RELAYS
AF-, AG-, AND AJ-TYPE
PIECE-PART DATA AND REPLACEMENT PROCEDURES

1.001 This addendum supplements Section 040-502-801, Issue 8. Place this sheet ahead of Page 1 of the section.

1.002 This addendum is issued to add information concerning the removal of mounting plate clips in 3.40.

Fig. 4.1—Modification of New Britain P58 Pliers for Clip Removal

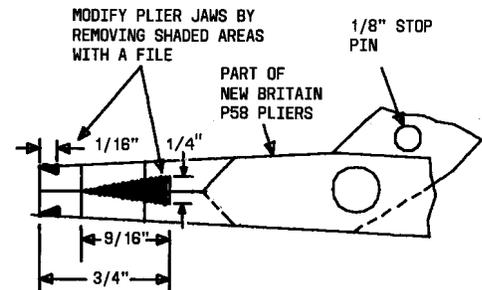
3.03.1 Modification of the New Britain P58 reverse action pliers, available from most automotive supply stores as a lock ring remover, is to be accomplished in accordance with Fig. 4.1. The 1/8-inch stop pin is to be installed in a hole drilled with an electric drill and located so as to limit jaw travel to approximately 1/2 inch for operator protection.

2.003 On Page 8, add new Fig. 4.1 as follows:
